**Subject:** FW: SUB23/0066 LUC23/0121 Melrose Road - RFI

Subject: RE: SUB23/0066 LUC23/0121 Melrose Road - RFI Stormwater

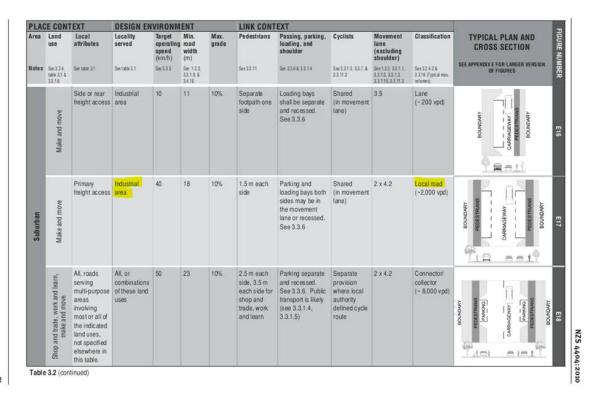
4m lane widths probably won't be sufficient to allow for on-street parking given the larger trucks that will operate through here. I also don't see any street trees, Open Spaces will require street trees on both sides of the road and the swale will require batters of 1:5 to allow for safe mowing.

Given the above, the design may need to be adjusted, perhaps as mentioned in the memo, the stormwater should rather be piped than conveyed via swale.

I see that a 2.5m wide shared path is proposed on one side of Melrose Road. This is a good idea in this location. Would the path be on the south or north side of Melrose Road?

To keep it simple at this stage, Council's nominated standards, in this case Figure E17 from Table 3.2 contained within NZS4404:2010, are relevant. With the 20m road corridor that is going to be available in Melrose Road, please see below the Industrial 'Local Road' standard that would apply.
